**CMD 26-H105.2**

**Written Submission from  
English River First Nation**

### **RE: ERFN Intervention- Orano McLean Lake Licence Renewal**

### Review of the Written Submission from Orano Canada Inc: Application to Renew the McClean Lake Operating License for 2-year Term CMD 26-H105.1

**Figure 4.6-11** (15 of 21) Variations in COPCs in Northern Pike collected from Exposure Lakes between 1994 and 2024

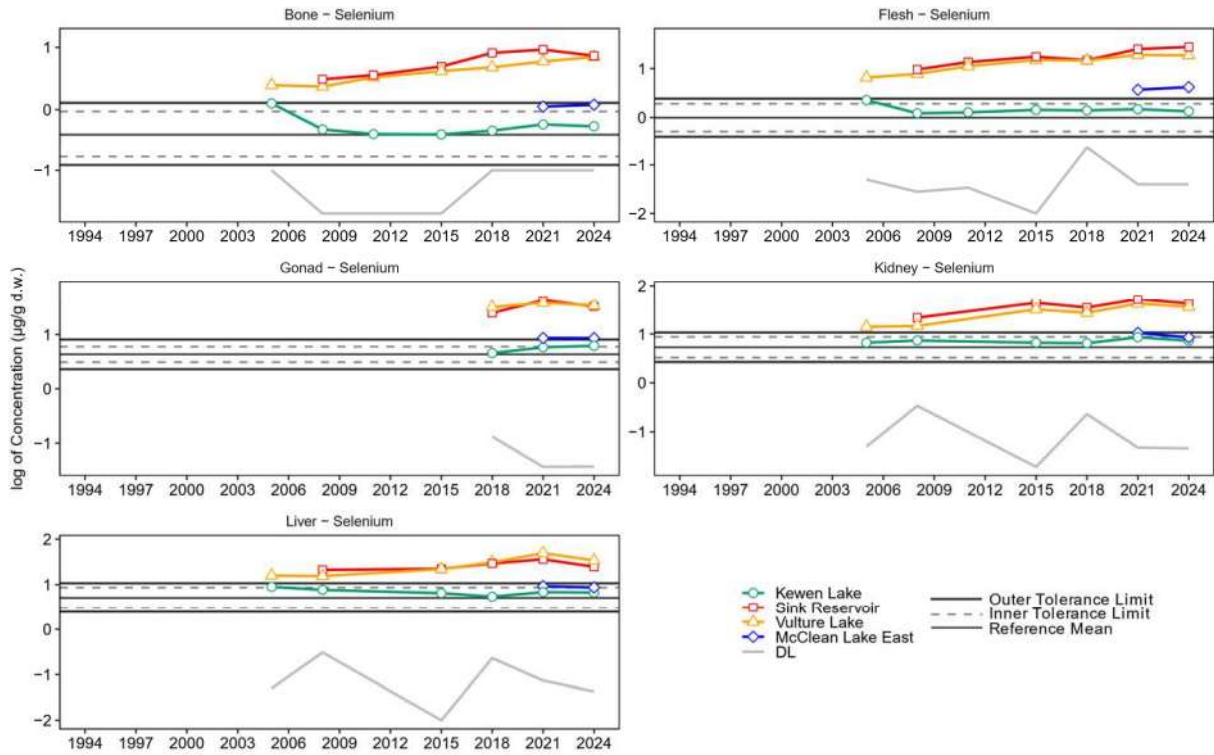
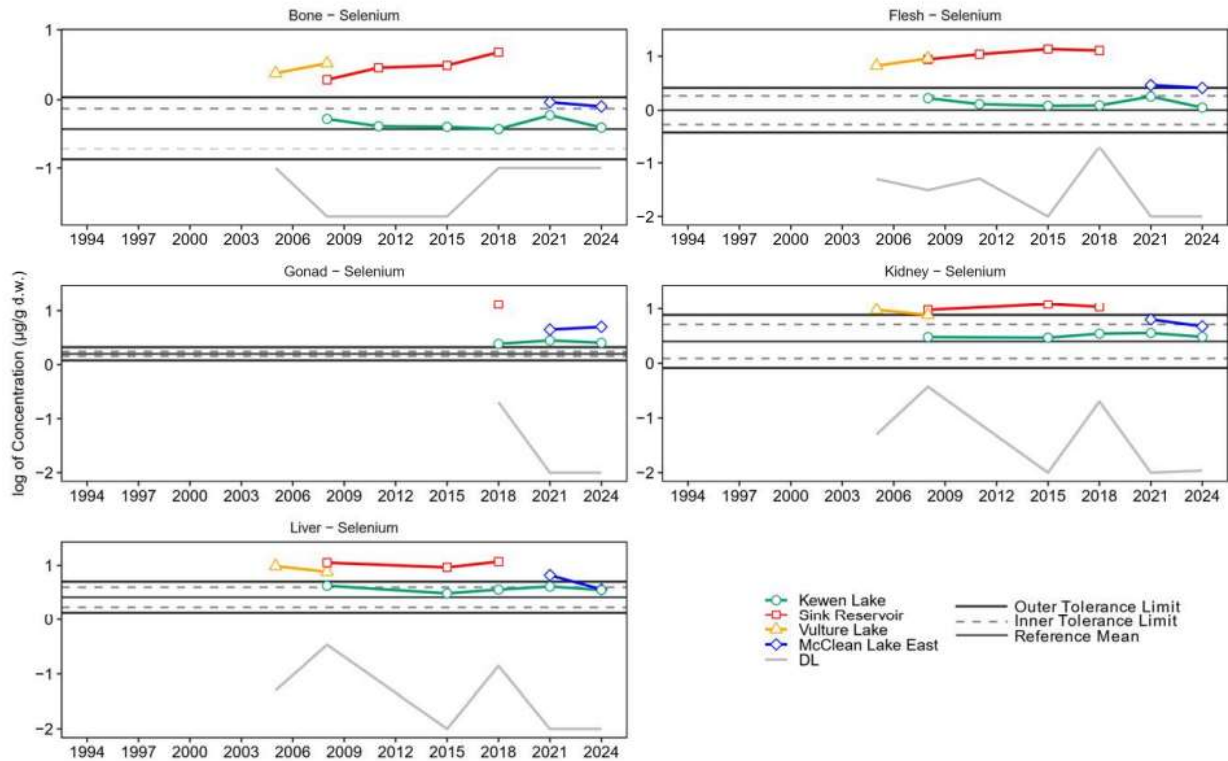
- Selenium concentrations in northern pike from Sink Reservoir and Vulture Lake exceeded site-specific reproductive benchmarks, consistent with long-term trends and ERA predictions.
- Other metals in fish tissues were generally stable and near reference or baseline levels in downstream lakes.
- Fish population monitoring in Collins Creek showed healthy populations, with burbot exhibiting good condition and growth in exposure areas.
- Slimy sculpin showed slightly lower reproductive success in exposure areas but maintained healthy growth and condition.
- No evidence of disease outbreaks, deformities, or population-level declines was identified.

**Figure 3.5-20 Water Quality Predictions – Base Case - Selenium**

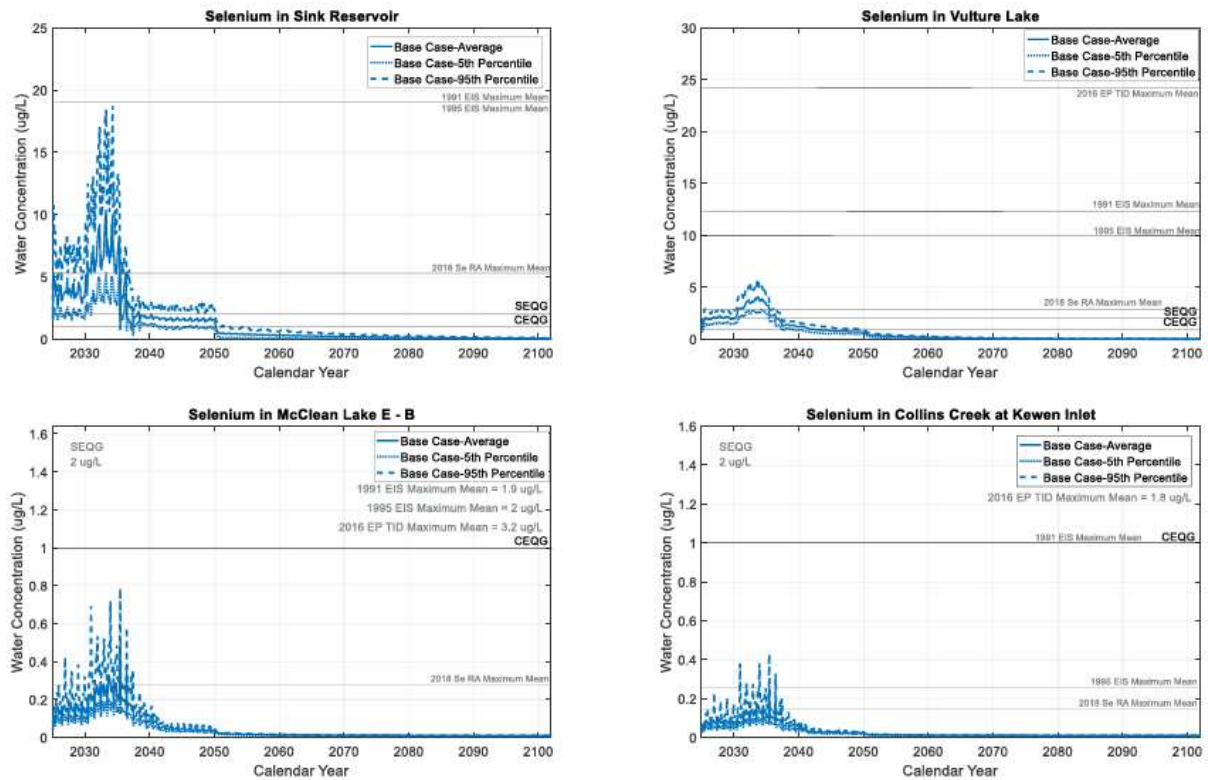
- Selenium aqueous concentrations are predicted to be above the 2018 Revised Selenium Forecast (REF2 page 98/388), while levels are expected to exceed guidelines in the S/V TEMS, no exceedances are anticipated at the downstream locations.
- Selenium predicted sediment concentrations are above the SEL within S/V TEMS. Within McClean Lake East Basin, selenium concentrations in sediment exceed the lowest effect level at this location (REF 2, page 30/388).
